**Docket No. 2012-01**

**Antrim Wind Energy, LLC**

**Final Memorandum of Lisa Linowes**

**On behalf of the Industrial Wind Action Group**

Fig. 11 – Measured LAeq,1-hr. vs. sound model estimate, Mars Hill Wind Farm, Maine

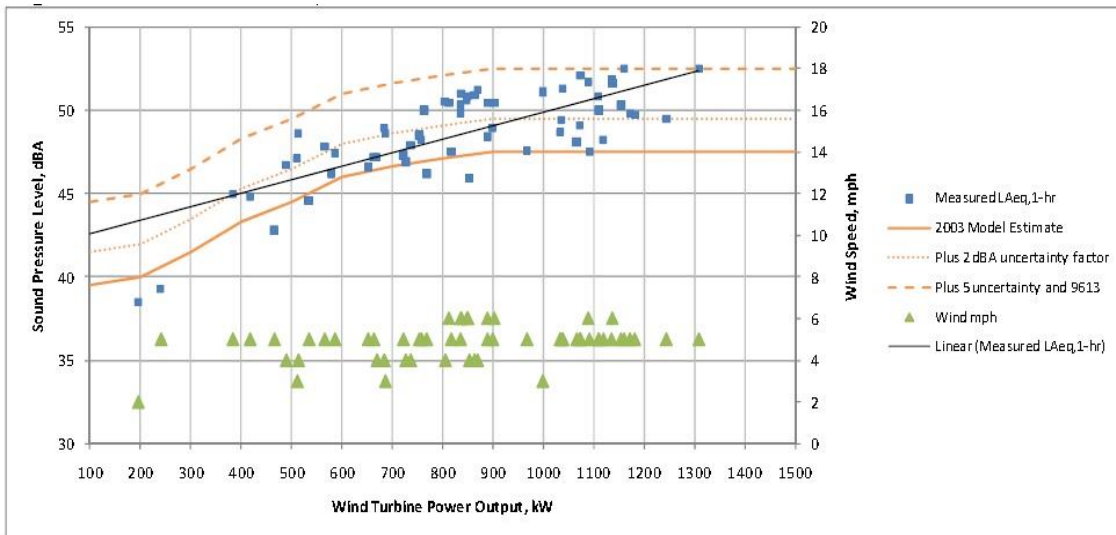
Mr. O’Neal agrees that in all cases, Wallace’s data show that measured noise levels (blue squares) exceeded modeled sound level results when the + 3dB was NOT applied. Mr. O’Neal agrees that the blue squares plotted between the small and large dashed curves in the figure indicate where the model under-predicted actual measured sound levels. (*Transcript 9/22/16, Day 4 morning at 117-119*) They also varied widely in sound level from one measurement to another, contrary to Mr. O’Neal’s repeated claims that modeled average sound levels will never be exceeded under any circumstances.

When the + 3dB is applied, Wallace’s model works better. However, it is necessary to highlight that Wallace’s model produced average noise predictions as he is also addressing Maine’s Leq-based

standard which requires averaging the measured noise levels over time. In figure 11 above, the measured noise is averaged over 1-hour (Leq 1-hr). Such averaging removes or flattens actual fluctuating turbine sounds like the blades passing by the tower. Under New Hampshire's "not-to-exceed" standard, all post-construction noise studies are to be taken using no averaging. Instead it requires meters to be set to measure 0.125-second ( $L_{fast}$ ) intervals and Leq metrics. (NH Site 301.18(e)) As previously stated, the ISO 9613-2 standard produces equivalent or *averaged* noise predictions (Leq) over a period of time.

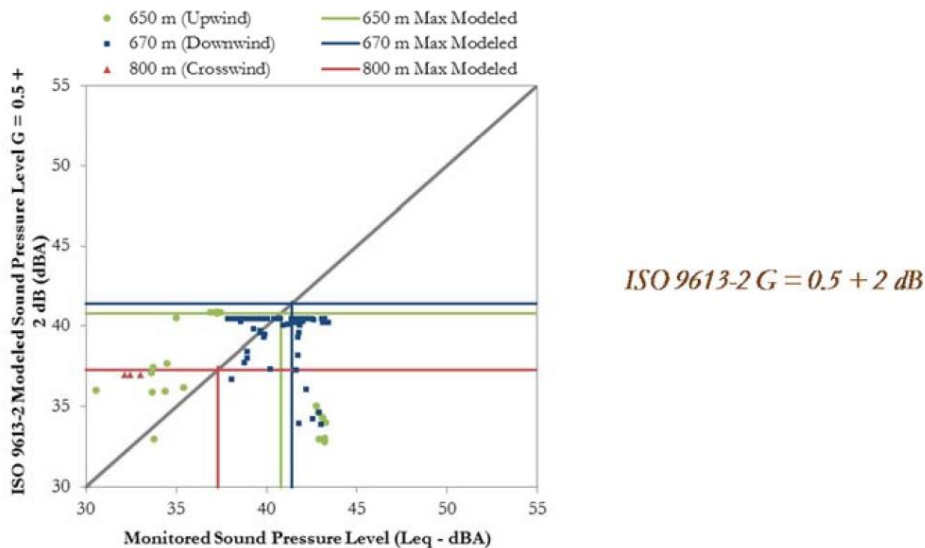
Mr. O’Neal agrees that the chart shown below and taken from the Mass CEC report (Exhibit WA-12 at 65) denotes conditions that are representative of the model he ran for Antrim, i.e. mountainous terrain with a G-factor of 0.5 and added K-factor while making no other adjustments. (*Transcript 9/22/16, Day 4 morning at 107, ln 9-21*)

Rather than supporting Mr. O’Neal’s claim, the figure reveals many cases where the model under-predicted actual turbine noise measurements. The blue and green dots in the lower right quadrant of the graph and right of the vertical lines represent repeated under-predictions by the model.

Mr. O’Neal insists the noise exceedances in the graph were an artifact of the turbine on/turbine off measurements. *(Transcript 9/22/16, Day 4 morning at 110-111)* But Mr. James disagrees. Data contamination to that degree would throw the results of the entire study into doubt. *(Transcript 10/19/16, Day 10 afternoon at 61, ln 19-24)* He further asserts that researchers would have taken care to remove transitional turbine sounds and not allow it to affect the data. *(Transcript 10/19/16, Day 10 afternoon at 61-63)* In any event, Mr. O’Neal agrees that turbine on/off events are not unusual and will occur in the field under normal operating conditions including when the winds drop below turbine cut-in speed or exceed turbine cut-out speed. *(Transcript 9/22/16, Day 4 morning at 114)* If such sound spikes occur at an operating Antrim project, there will be properties in Antrim that will experience noise levels that exceed the permitted not-to-exceed limits allowed under the SEC noise standard.

We note that Mr. O'Neal could not explain why the Mass CEC report (on which he collaborated) found no such transition exceedances when the G-factor for the model was set to 0 (hard ground). (*Transcript 9/22/16, Day 4 morning at 113, ln 5-21*)
